110 Regent's Park Road NW1 8UG

Response to CAAC Comments

November 2022

2. Comments From CAAC: Overview

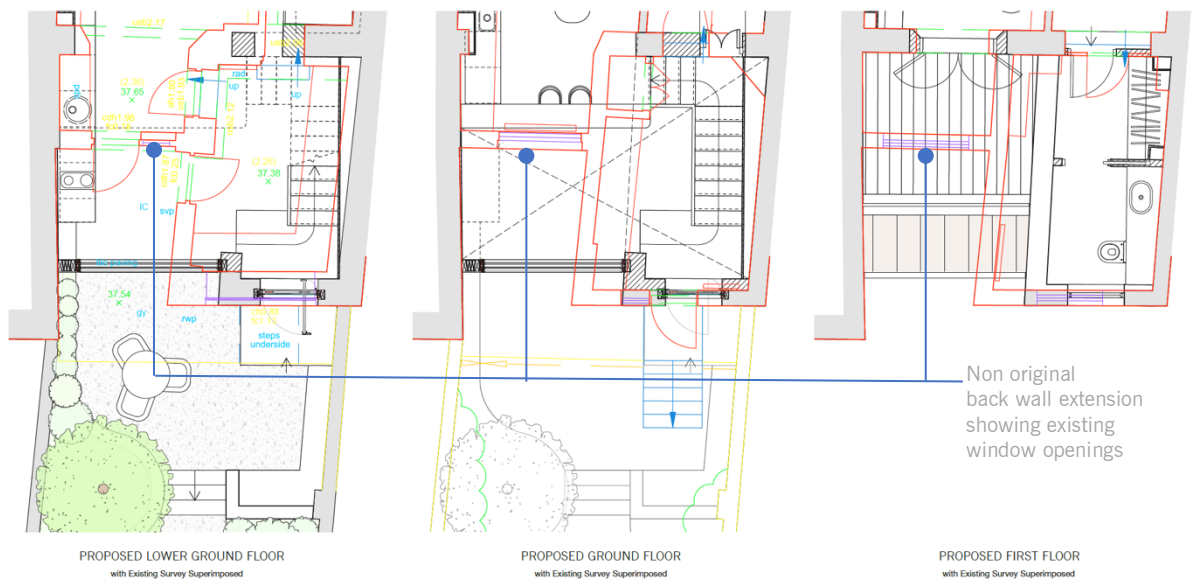
- a) No objection to the reworking of the masonry in the existing rear addition
- b) No objection to the rebuilt back addition
- c) The Committee objects to alterations to the fenestration and glazing of the lower ground, ground and first floors to the rear elevation of the main house.
- d) The Committee acknowledges that the rear elevation to the lower three floors of the main house has been rebuilt (refer to plans). It incorporates windows which reflect the original and significant forms associated with the house as a whole.
- e) The Round headed window at rear ground floor level relates to the round headed openings to windows and porch on the front elevation.

7. Architect's Response: Main window

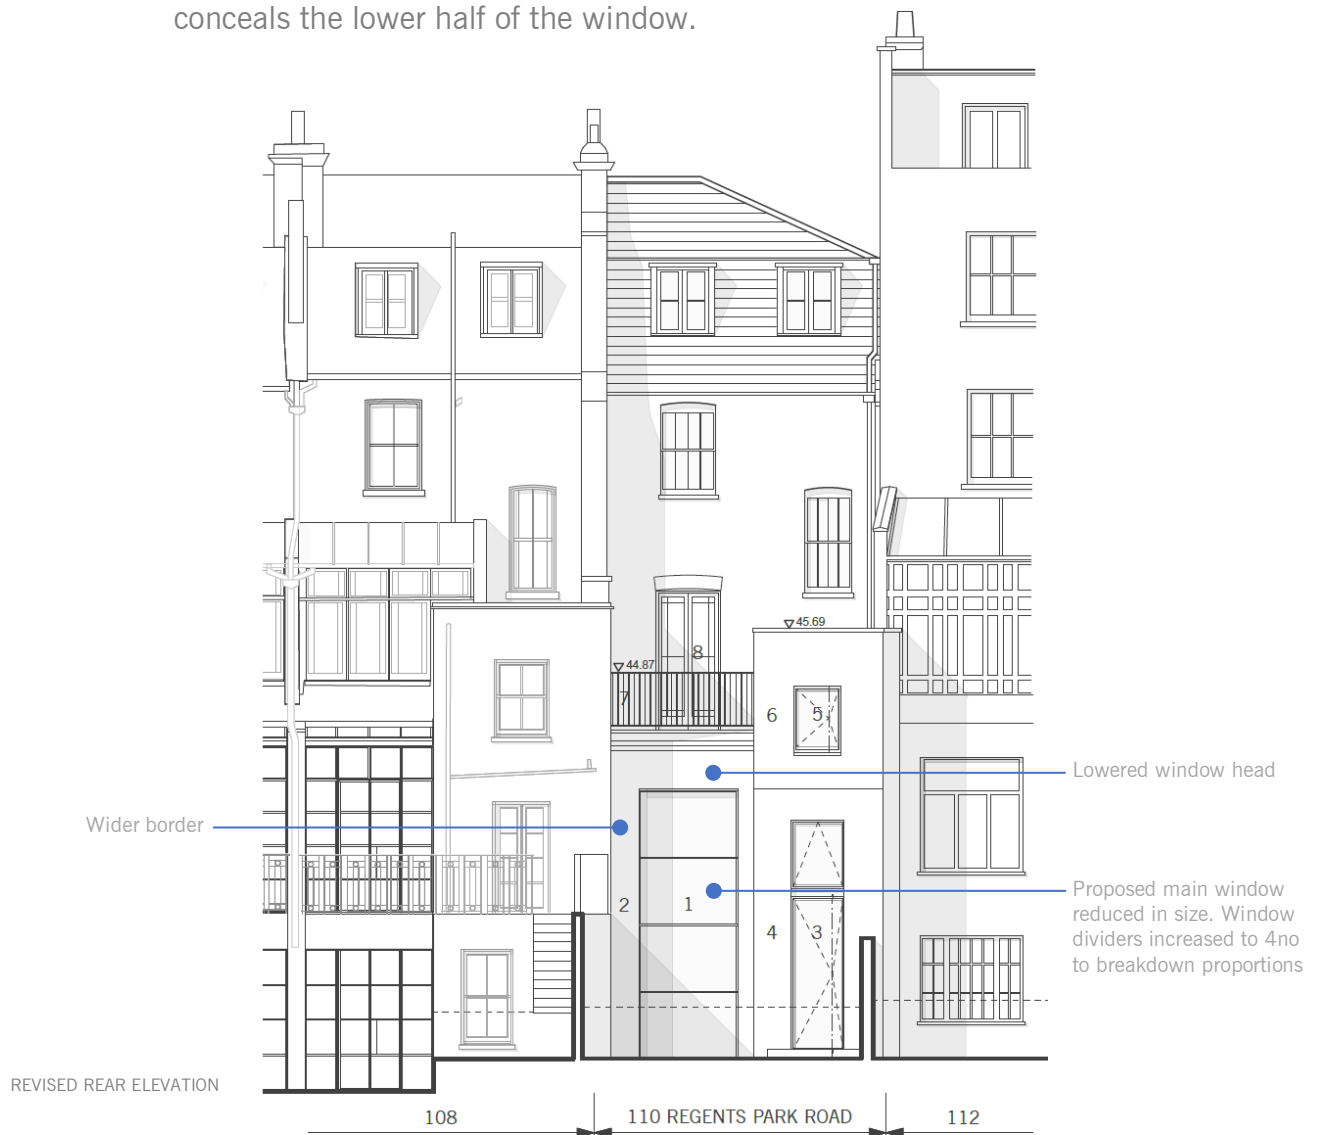
The Committee objected *'to the main window which is out of scale to the house as a whole, and unbalances the relationship between the lower stories and upper stories of the house. This would neither preserve nor enhance the character or appearance of the conservation area'*.

- a) In response to the concerns of the Committee, the height and width of the proposed main rear window are reduced, creating a solid rendered border and lowered head that is more in keeping with the traditional character and setting.
- b) Reducing the size of the main window allows the scale and proportion of the glazed area to be more in balance with the neighbouring permitted window openings to Nos 106 & 108.
- c) In addition to the reduced window size, the full elevation cannot be seen from the gardens of 1 Chalcot Crescent and Rothwell Street as the garden wall conceals the lower half of the window.

New main window's impact is reduced from the gardens of 1 Chalcot Crescent and 1 Rothwell Street as the garden wall conceals the lower half of the window

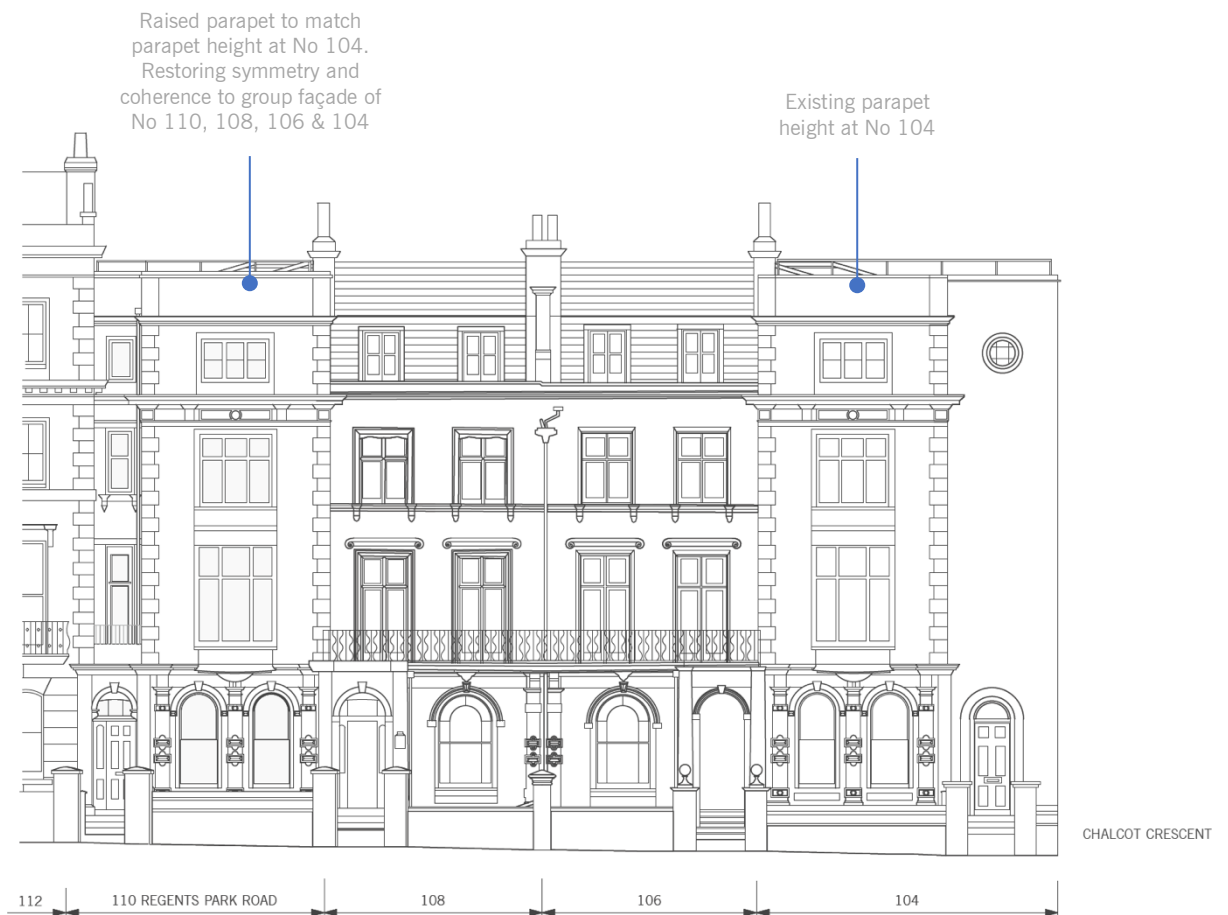
The Committee expressed general concern about the impact on neighbours living in a relatively tight spaced area as it relates to the character of the conservation area, respect for each other amenity. Light and noise pollution are particular concerns.

- a) As noted previously, the reduced size of the main window and lowered head is consistent with the size and proportion of window openings of neighbouring properties.
- b) The reduction of the glazed area and the use of blinds at night act as a barrier to light and noise pollution.
